Access Compliance Report Public Rights-of-Way (Curb Ramps)

Intersection ID: 10018249 Main Street: IRWIN VALLEY CT **Cross Street: N/A** Location: Ε **ADA ID: B8BEE5F0463F** Ramp Type: BlendTrans1 Initial Pass/Fail: Fail **Overall Compliance: No Severity Score:** 25

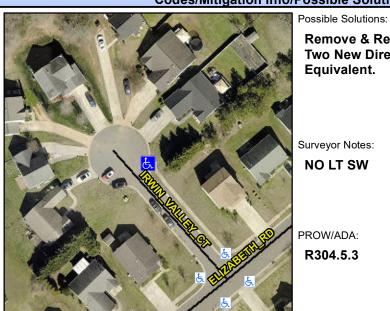
IRWIN VALLEY CT Street 1 Name Stop Condition-Street 1 None Street 2 Name N/A Stop Condition-Street 2 N/A Remove & Replace Curb Ramp With **Two New Directional Ramps or** Equivalent.

NO LT SW

R304.5.3

Compliance Description		Data	Comp	liance Description	Data
N/A	Ramp Length (in)	44.5	Yes	BlendTrans Slope (%)	4.6
Yes	Ramp Width (in)	48.0	No	BlendTrans XSlope (%)	7.3
N/A	Flare Type LT	N/A	N/A	Flare Type RT	N/A
N/A	Flare Slope LT (%)	N/A	N/A	Flare Slope RT (%)	N/A
N/A	Flare Traversable LT?	N/A	N/A	Flare Traversable RT?	N/A
N/A	Landing Length (in)	N/A	N/A	DWS Provided?	N/A
N/A	Landing Width (in)	N/A	N/A	DWS Contrast?	N/A
N/A	Landing Slope (%)	N/A	N/A	DWS Length (in)	N/A
N/A	Landing X Slope (%)	N/A	N/A	DWS Full Width?	N/A
N/A	Landing Curb? (Y/N)	N/A	N/A	DWS Offset (in)	N/A
N/A	Shared Landing?	N/A			
N/A	Gutter Ponding?	N/A	N/A	Gutter Slope (%)	N/A
N/A	Gutter Lip Ht (in)	N/A	N/A	Gutter X Slope (%)	N/A
N/A	Painted X Walk1?	No	N/A	Painted X Walk2?	N/A
	X Walk 1 Direction	To W		X Walk 2 Direction	N/A
	X Walk 1 Width (in)	N/A		X Walk 2 Width (in)	N/A
	X Walk 1 Slope (%)	11.6		X Walk 2 Slope (%)	N/A
	X Walk 1 X Slope (%)	7.8		X Walk 2 X Slope (%)	N/A
